INNER WEST COUNCIL

DEVELOPMENT ASSESSMENT REPORT

| Application No. | DA20160025.03 |
| Address | 20-22 George Street, MARRICKVILLE NSW 2204 |

Figure 1 – Proposed rear building setback (fourth floor)

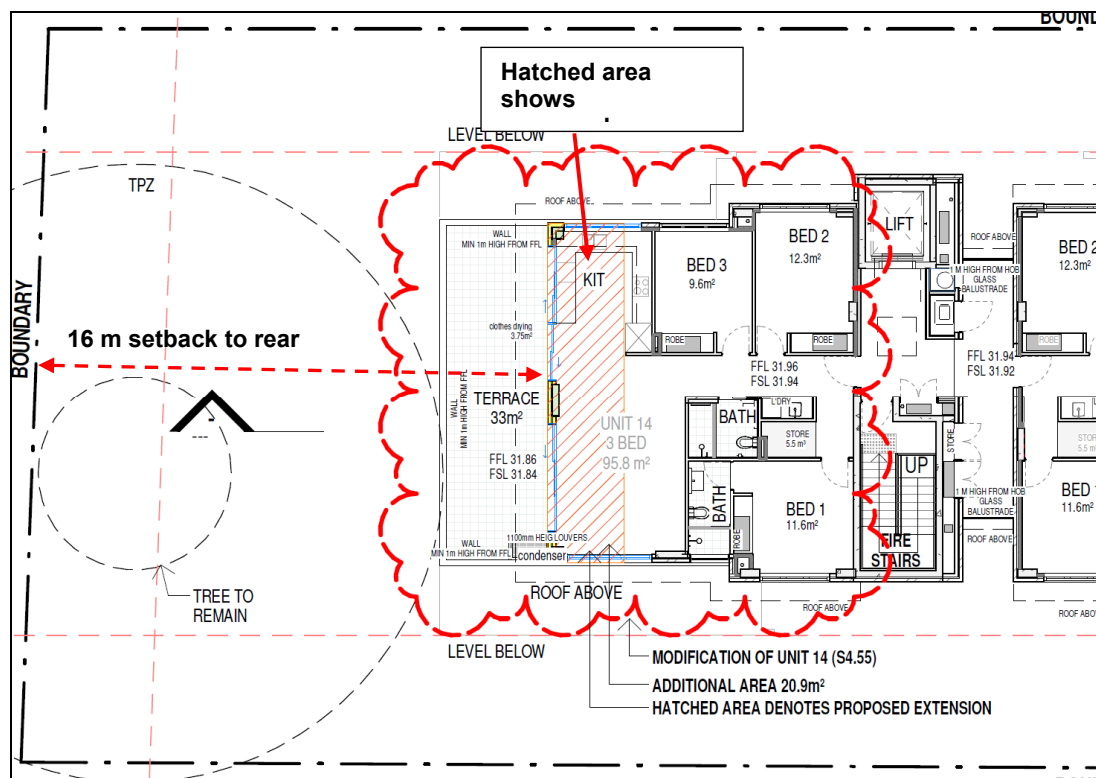
The proposed modification would reduce the rear setback of the fourth floor by 2.4 m to 16 m (refer to **Figure 1**). The proposal exceeds the 6 m minimum setback requirement for a RFB up to four storeys under the ADG.

SECTION A-A
1:100

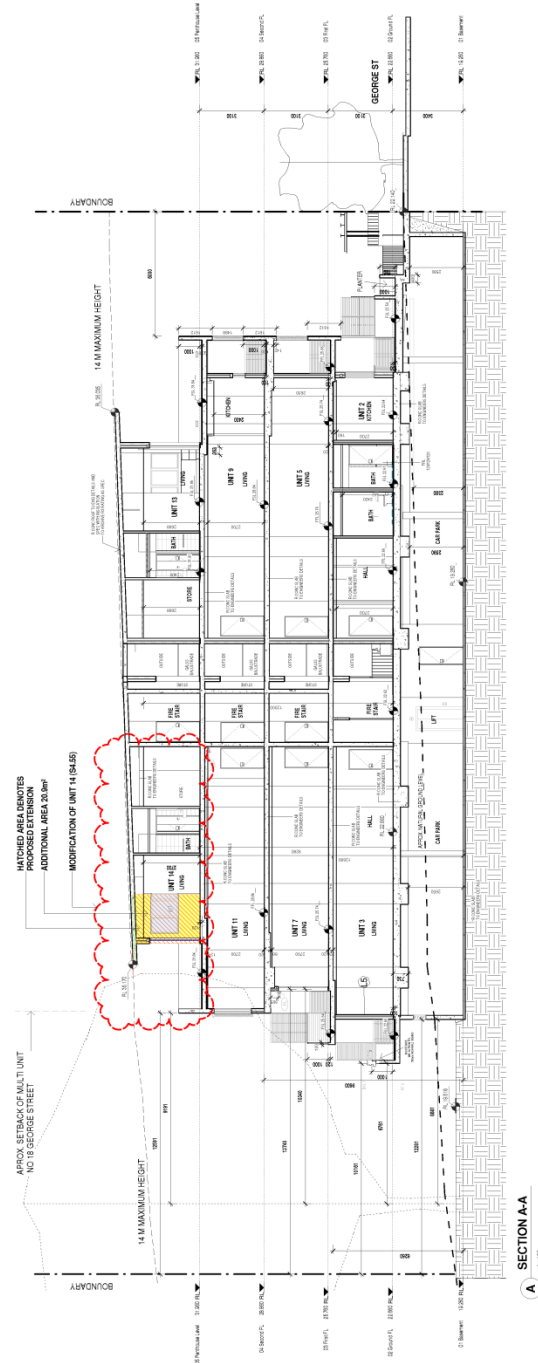
| Issue raised | Council’s Response |
|-----------------------------------------------------------------------------------------------------------------------------------------------------------------------------------------------------------------------------------------------------------------------|---------------------------------------------------------------------------------------------------------------------------------------------------------------------------------------------------------------------------------------------------------------------------------------------------------------------------------------------------------------------------------------------------------------------------------------------------------------------------------------------------------|
| The roof line is not shown accurately on the drawings for the modification and extending it would exceed the limit. | The originally lodged architectural plans show a flat roof form. Council subsequently requested the retention of the approved skillion roof to ensure the development followed the slope of the land and complied with the 14m height development standard. The amended architectural |

| | plans submitted with the modification application include a skillion roof above the proposed extension, which now complies with the 14 m height development standard under MLEP 2011. |

1 WINTER 21 JUN 9AM SHADOWS
1:1,200

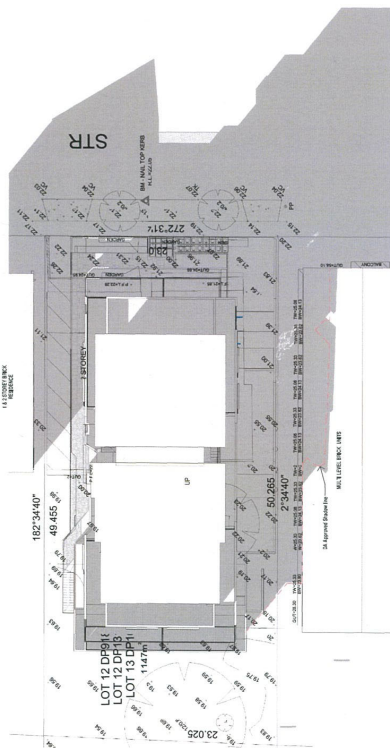
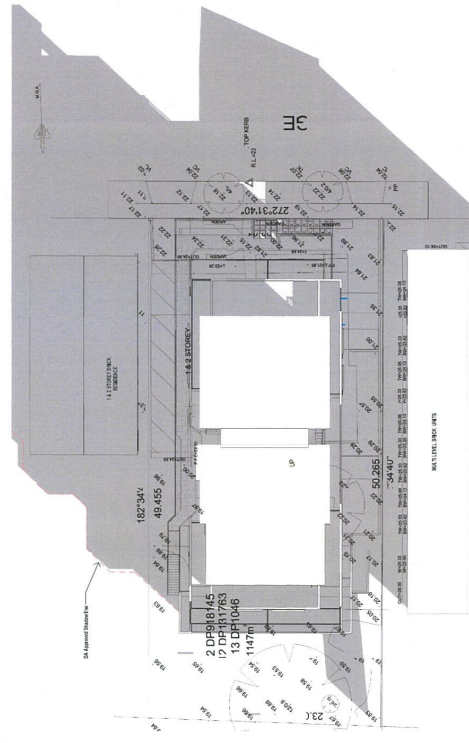
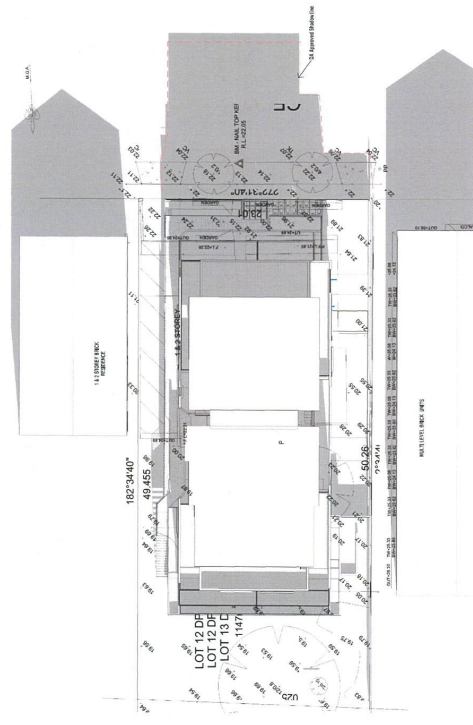
At 9:00 am the modified development would result in some minor additional shadow to the roof of the existing building on the adjoining property to the west at 18 George Street. At midday there would be some minor additional shadow falling to the street on George Street. At 3:00 pm the additional shadow affecting the adjoining property at 22 George Street is negligible. Given the north-south orientation of the site, the adjoining residential properties would continue to receive solar access in accordance with MDCP 2011. The modified development therefore would not result in any unreasonable overshadowing to the adjoining properties.
